Access Compliance Report

Public Rights-of-Way

(Curb Ramps)

Intersection ID: 52919	Main Street: HOOVER_CREEK_BV	Cross Street: WALKER_BRANCH_DR	Location: NE
ADA ID: 3C719C930EF5	Ramp Type: Perp	Initial Pass/Fail: Fail	Overall Compliance: No
Severity Score: 10			
Codes/Mitigation Info/Possible Solution		Field Measurements/Component Compliance

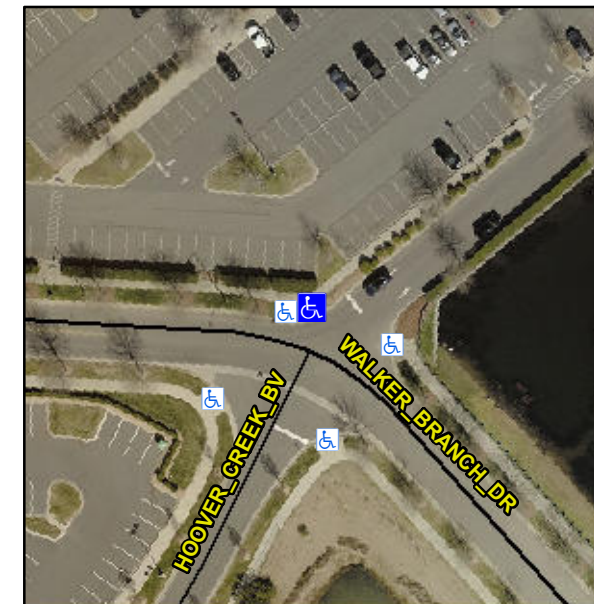
Not Found, R304.5.1, R304.5.3

Compliance	Description	Data	Compliance	Description	Data
N/A	Ramp Length (in)	75.0	Yes	Ramp Slope (%)	7.8
No	Ramp Width (in)	43.0	No	Ramp XSlope (%)	4.0
N/A	Flare Type LT	N/A	N/A	Flare Type RT	N/A
N/A	Flare Slope LT (%)	N/A	N/A	Flare Slope RT (%)	N/A
N/A	Flare Traversable LT?	N/A	N/A	Flare Traversable RT?	N/A
N/A	Landing Length (in)	N/A	N/A	DWS Provided?	N/A
N/A	Landing Width (in)	N/A	N/A	DWS Contrast?	N/A
N/A	Landing Slope (%)	N/A	N/A	DWS Length (in)	N/A
N/A	Landing X Slope (%)	N/A	N/A	DWS Full Width?	N/A
N/A	Landing Curb? (Y/N)	N/A	N/A	DWS Offset (in)	N/A
N/A	Shared Landing?	N/A			
N/A	Gutter Ponding?	N/A	N/A	Gutter Slope (%)	N/A
N/A	Gutter Lip Ht (in)	N/A	N/A	Gutter X Slope (%)	N/A
N/A	Painted X Walk1?	No	N/A	Painted X Walk2?	N/A
	X Walk 1 Direction	To SE		X Walk 2 Direction	N/A
N/A	X Walk 1 Width (in)	N/A	N/A	X Walk 2 Width (in)	N/A
	X Walk 1 Slope (%)	2.4		X Walk 2 Slope (%)	N/A
	X Walk 1 X Slope (%)	3.4		X Walk 2 X Slope (%)	N/A

Remove & Replace Entire Ramp.
